**Regulation No. XXX**

**Uniform Provisions Concerning the Approval of Mechanical Coupling Components for  
Agricultural Vehicles**

Testing: Mechanical coupling devices for agricultural vehicles

Last updated: 21 July 2011

Figure 19 – Principal dimensions of standard coupling ring d2-40

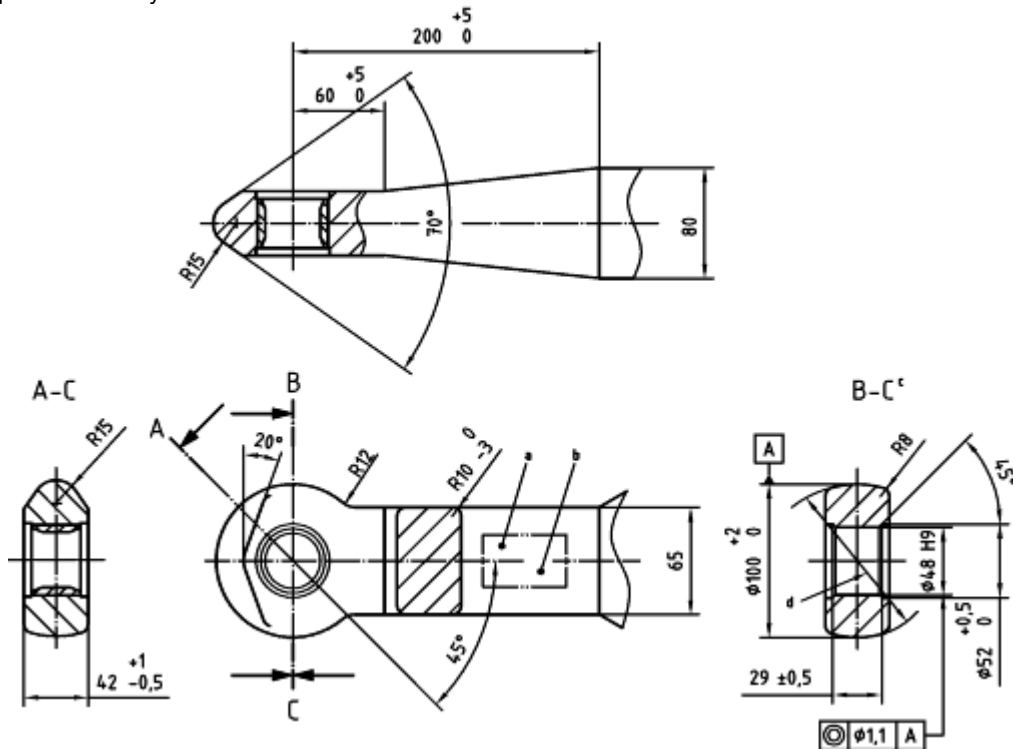
All coupling rings of Class d2-40 shall be designed so that they are able to satisfy the tests given in **xx** of annex 6. **This point is not present in annex 6!**

Figure 20 – Hitch ring 50

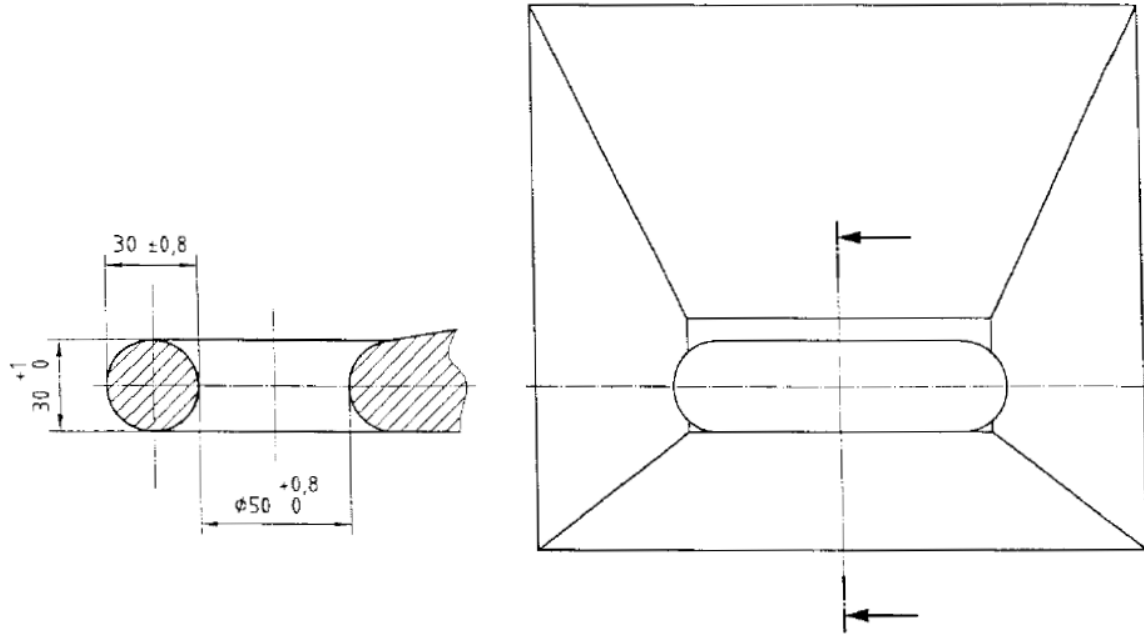
All coupling rings of Class d3 shall be designed so that they are able to satisfy the tests given in **xx** of annex 6. **There is no point for d3.**

Coupling rings of Class d3 shall conform to Figure **xx** in external shape and external dimensions.
